FIELD CHANGE NO. 2

RECORD DRAWING
09/04
REV.11/17

TITLE: CENTRAL – ATRISCO DRAINAGE IMPROVEMENTS
46th STREET
PLAN & PROFILE STA. 20+00 TO 25+25.00

City Project No.	Zone Map No.	Sheet	Of
674902	K-12-Z	3.2	21

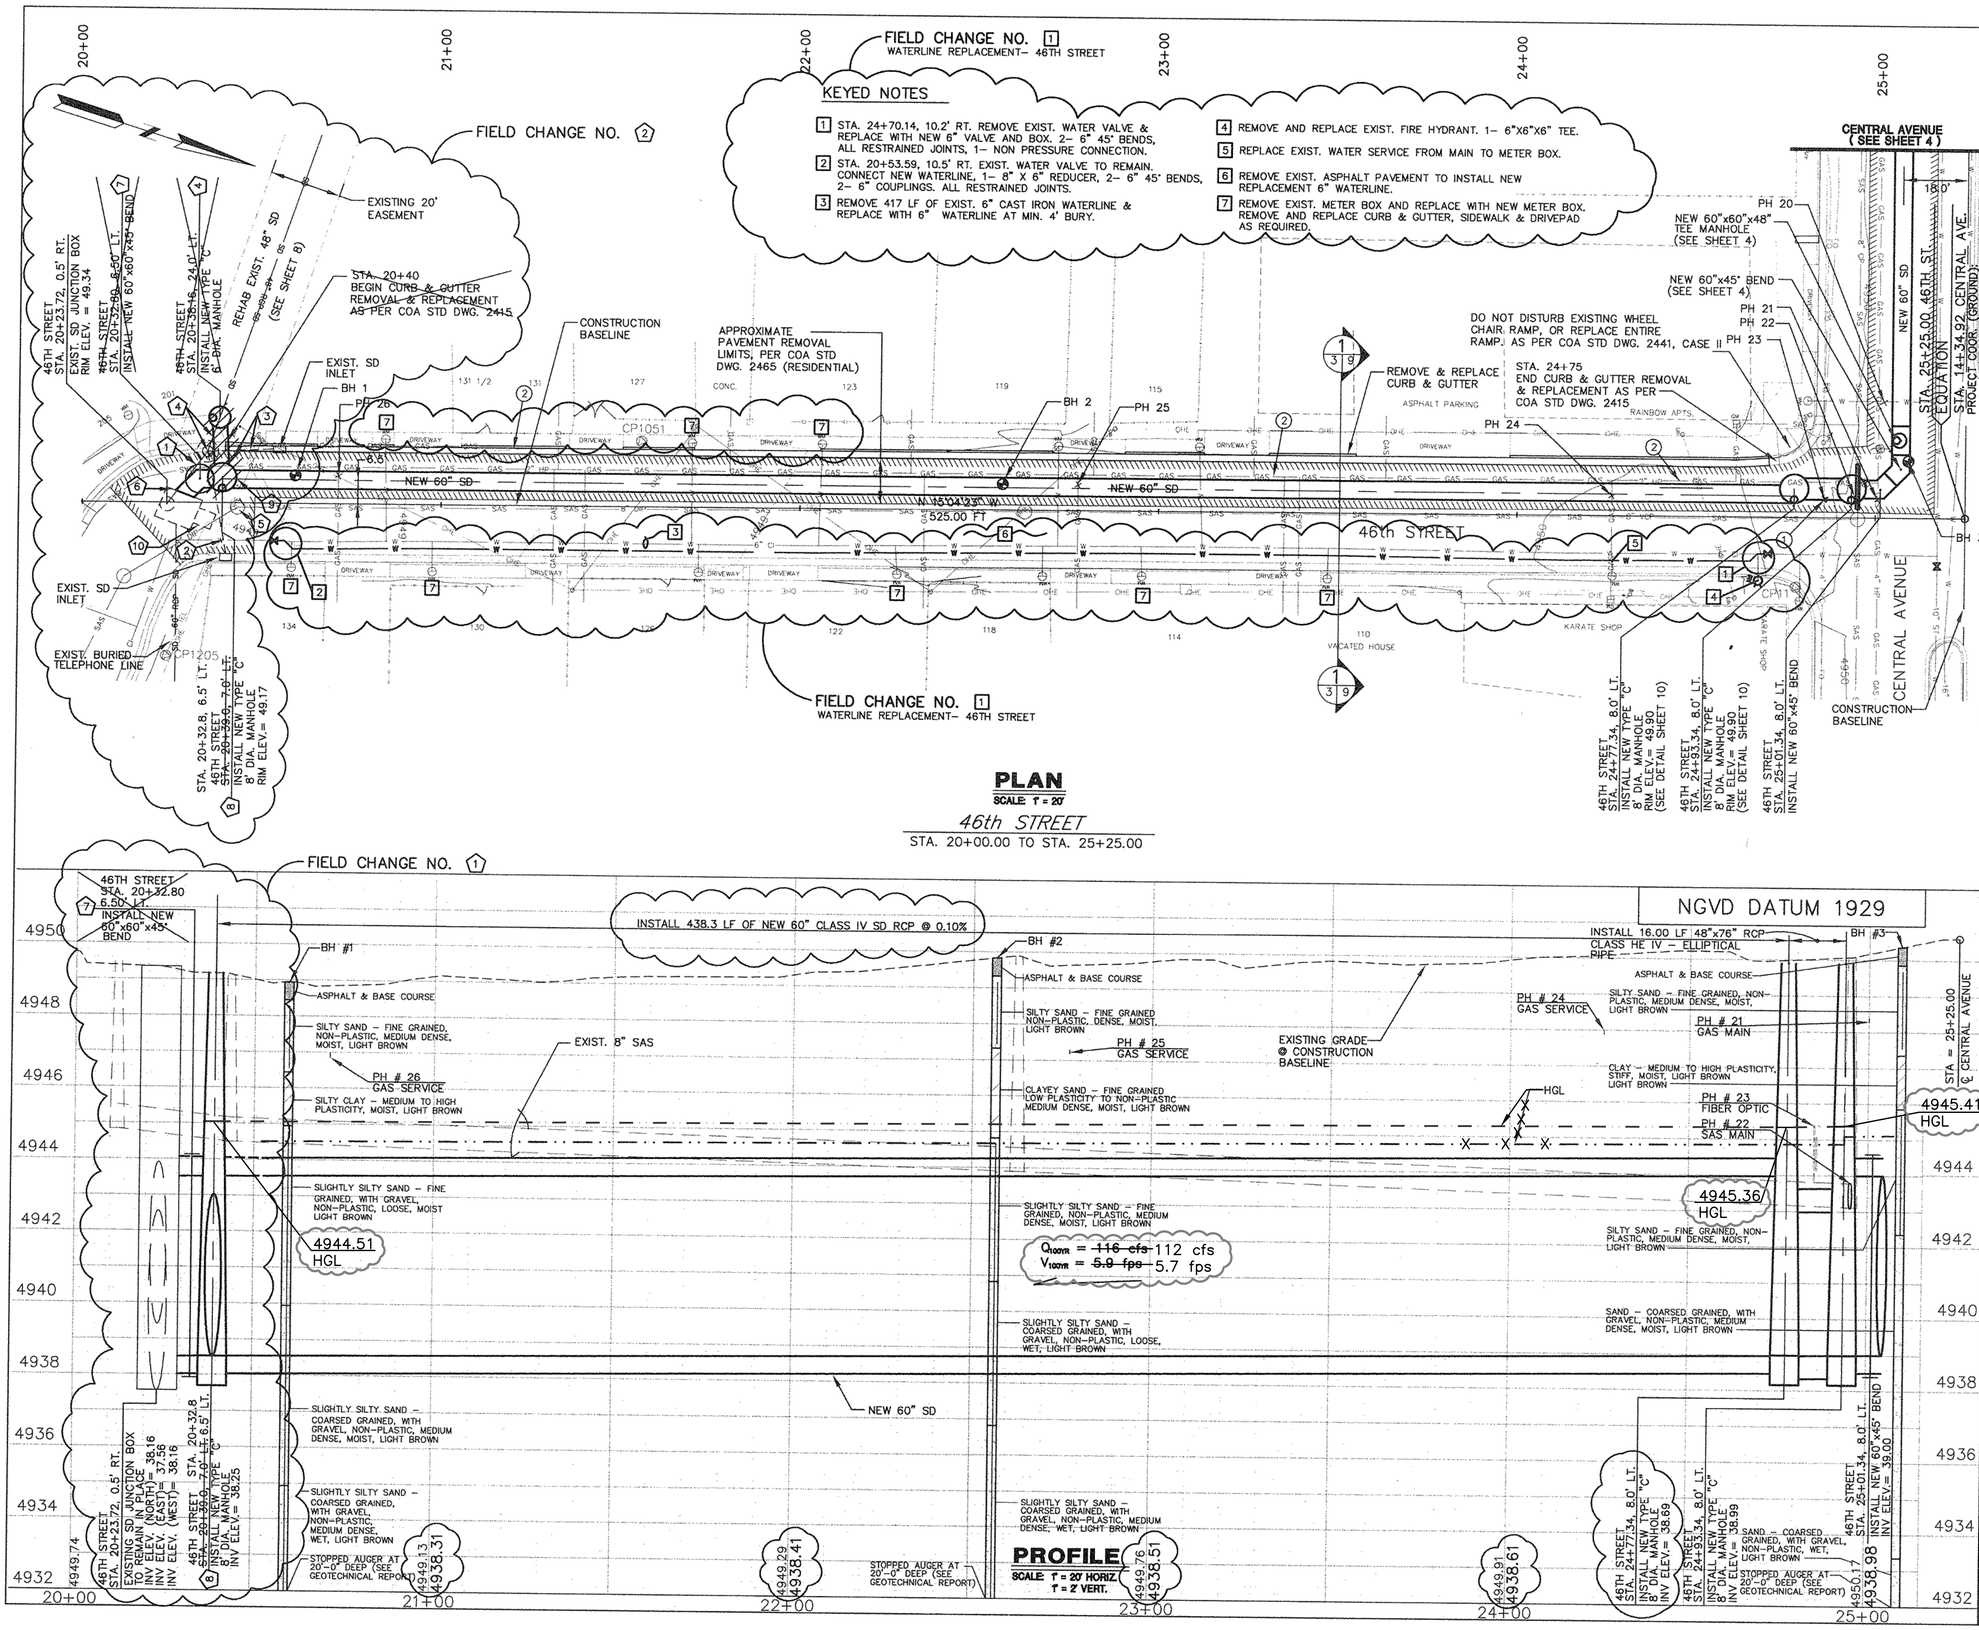
1. REMOVE APPROX. ~~12~~ 8 LF OF EXIST. 48" RCP BETWEEN EXIST. JUNCTION BOX AND EXIST. MANHOLE.
2. REMOVE APPROX. 20 LF OF EXIST. 18" RCP LATERAL LINE. RECONNECT TO NEW 8' DIA. MANHOLE.

3. REMOVE APPROX. 8 LF OF EXIST. 18" RCP LATERAL LINE. RECONNECT TO NEW 8' DIA. MANHOLE.
4. ~~REMOVE EXIST. MANHOLE. REPLACE WITH NEW 6' DIA. MANHOLE AT NEW ANGLE POINT. REMOVE EXIST. 48" RCP AS REQ'D TO NEAREST JOINT. INSTALL NEW 48" CLASS III RCP STORM DRAIN BETWEEN NEW 6' DIA. MANHOLE AND NEW 8' DIA. MANHOLE. MAINTAIN EXIST. GRADE ON 48" PIPE.~~

7. ~~INSTALL 60"X60"X45° BEND.~~
8. BUILD 8' DIA. TYPE C MANHOLE.
9. INSTALL 60" DIA. CLASS IV RCP ~~STARTING AT STA. 20+42.50, 6.50' LT. INV. EL.= 38.25.~~

NO.	DATE	REMARKS	BY
4			
3			
2	3/26/04	FIELD CHANGE NO. 1 REV. CONNECT. TO JB	RL
1	3/26/04	FIELD CHANGE NO. 2 REV. WATER RELOC.	RL
